IMPORTANT SAFETY RECALL

NHTSA Recall No. 23V-396

Terex Utilities	
SAFETY NOTICE	SN719

SUBJECT: Subframe Insert Welds

Figure 1. Area of subframe to inspect

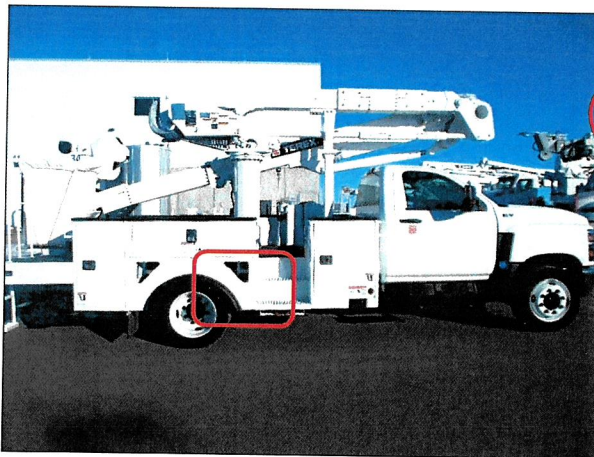
1. Immediately inform all users, operators, and supervisors that the bottom side of the subframe where the aerial device mounts must be visually inspected before further use.
2. Inspect to determine if welds are cracked for the threaded inserts using the figures below as reference.

3. If no cracks are detected during the visual inspection the unit can be used following the instructions in the continued use section in this bulletin as well as all operator, maintenance, and inspection requirements as specified in the manuals.
4. If cracking is detected in the welds, do not use the machine and contact Terex Utilities Warranty Department using the contact information in this bulletin.

Figure 2. Weld to inspect

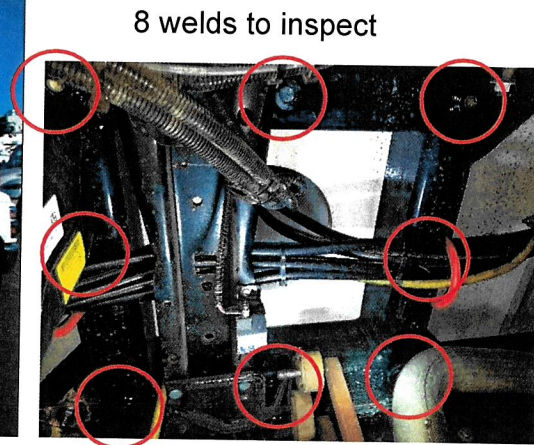
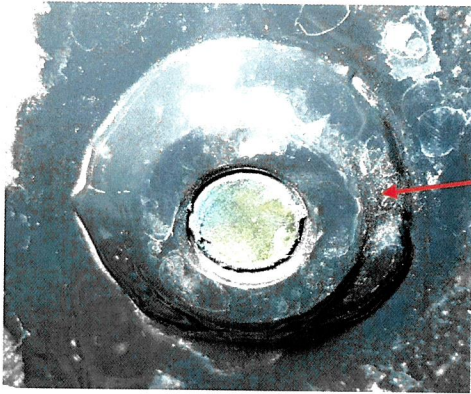
Inspect this weld
for cracks

Terex will complete Field Service Kit Z1650 at no cost to the customer. The Field Service Kit Z1650 provides instructions for removing the welds for the threaded inserts at the top of the subframe and to reweld the top side of the inserts to the subframe tubes.
